Informal document **GRPE-74-03-Rev.1**  
74<sup>th</sup> GRPE, 9-13 January 2017,  
agenda item 3(b)

**Proposal for amendments to ECE/TRANS/WP.29/GRPE/2017/7  
(Consolidated version)**

This document shows the amendments to ECE/TRANS/WP.29/GRPE/2017/7 proposed in GRPE-74-02 as a consolidated version. Modifications to ECE/TRANS/WP.29/GRPE/2017/7 are marked in track changes.

## **Global technical regulation on Worldwide harmonized Light vehicles Test Procedures (WLTP)**

Figure A8.App1/4

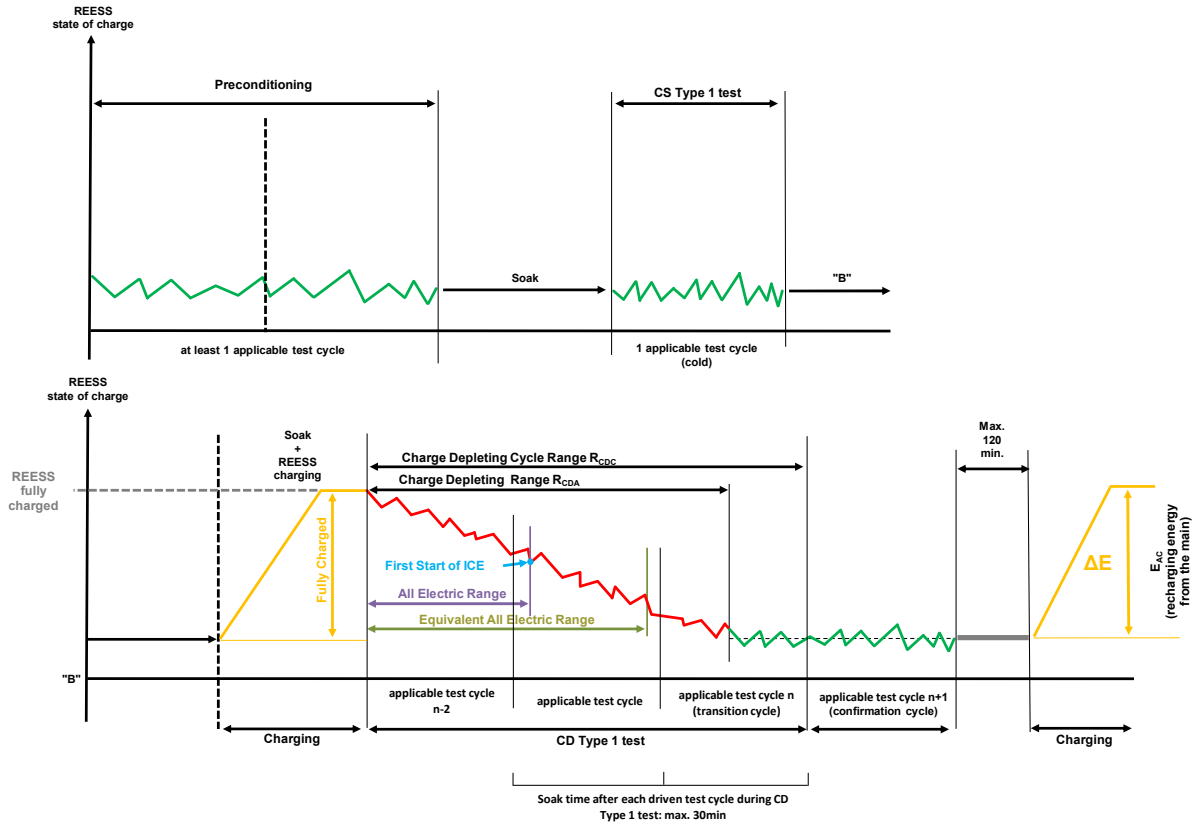
OVC-HEVs, charge-~~depleting~~-sustaining Type 1 test with subsequent charge-~~sustaining~~-depleting Type 1 test
